Office Action Summary

10/516,528

BEDEN ET AL.

DETAILED ACTION

FIG. 7

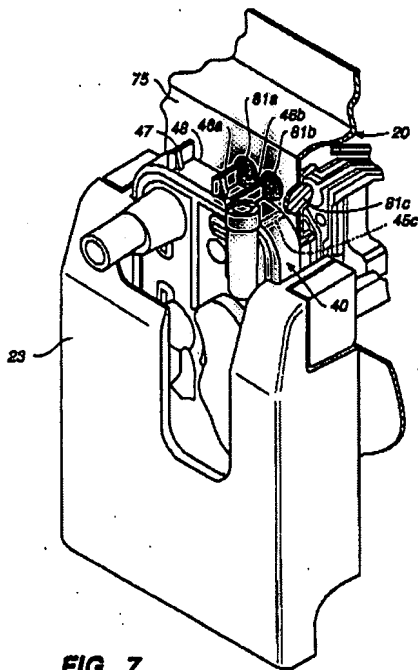
Regarding claims 1 and 3, Pastrone teaches a liquid treatment machine 20 including cassettes (30, 40, 50, 60) for different applications inserted therein. The cassettes have a rigid body (131, 133) and a foil (elastomeric member 133). The fitted chambers and passages of the cassette are best shown in figures 2-4 of U.S. Patent No. 4,927,411, incorporated by reference into Pastrone (col. 5, line 1-9). It is noted that it is the examiner's interpretation of claim 1 that only 1 cassette is required by the claim language (the recitation of "cassettes" is part of

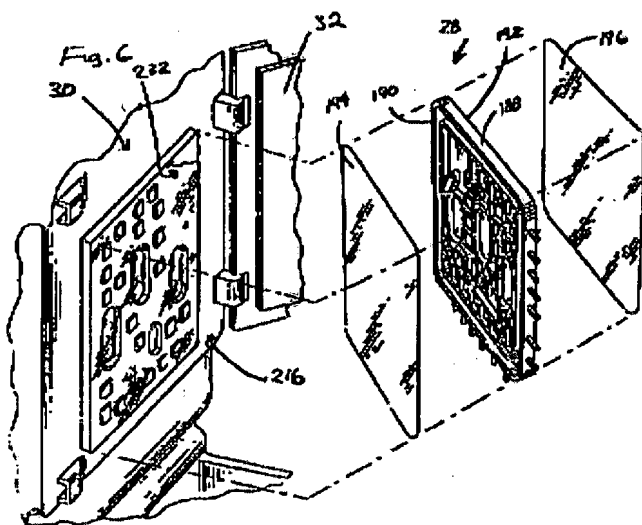
the intended use). However, figures 2-5 and 2A-5A of Pastrone depict different integration

shapes (i.e. different interfacing configurations) resulting from the respective ID flag configurations.
